Subject: Class II permissive change Request

FCC ID: N4ZFG400

Pursuant to CRF Section 2.1043, FLYSKY RC MODEL TECHNOLOGY CO., LTD requests a Class II permissive change to update the filing. All of the changes are not effect to the RF performance, function and power.

Change list:

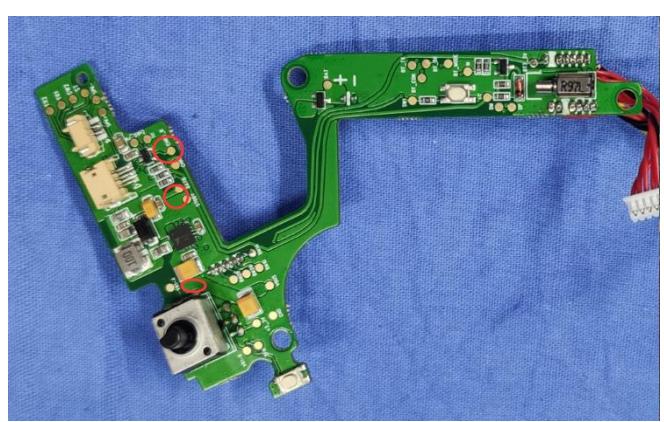
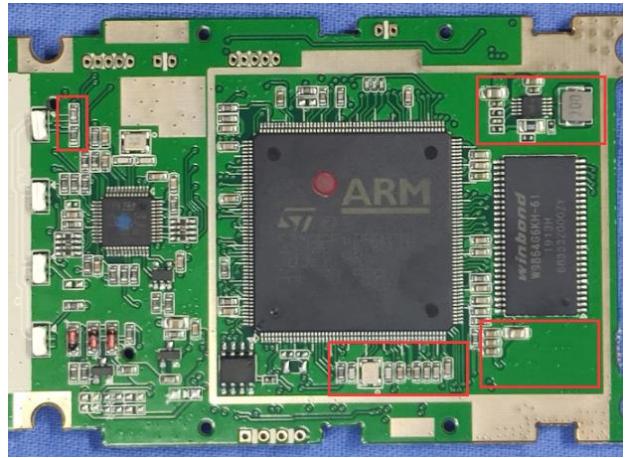
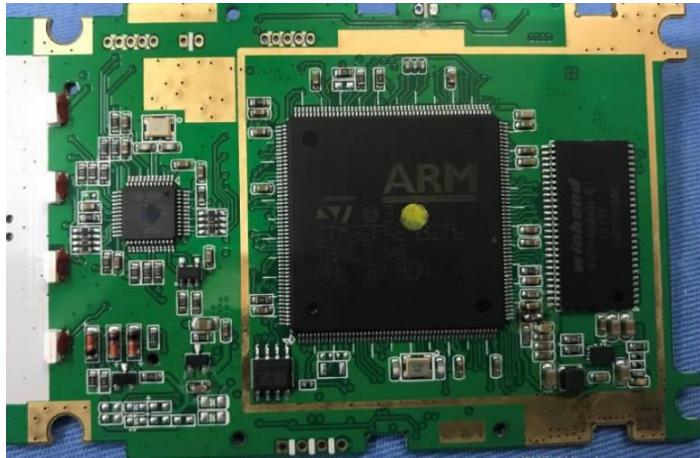
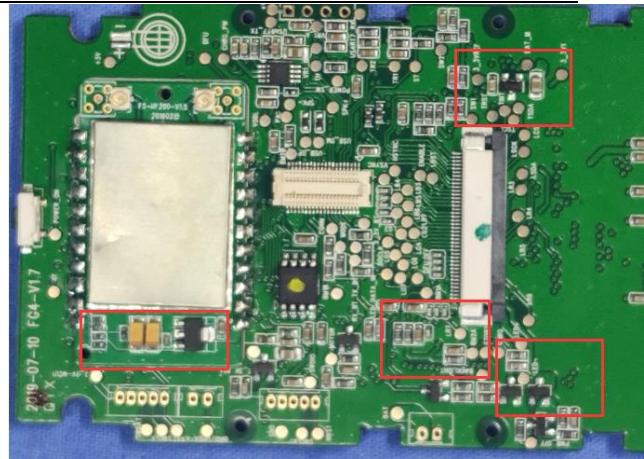
1. Remove all devices outside the JW3633 Charging circuit
2. IC model 1461 of RF module power supply is replaced with ly2509, no change occurred on RF circuit; layout of 9013 triode is modified.
3. The IC model of SDRAM power supply is mp1461, which is replaced by ltc3440, which is moved from the lower position to the upper position; some capacitors are added to IO port of stm32f429bit6 for high frequency filtering.
4. Reduce 3 power inductors;
5. Remove a 4300mA/h-lithium battery.

Note: the above modification is better for EMC / EMI optimization, and there is no change for RF circuit
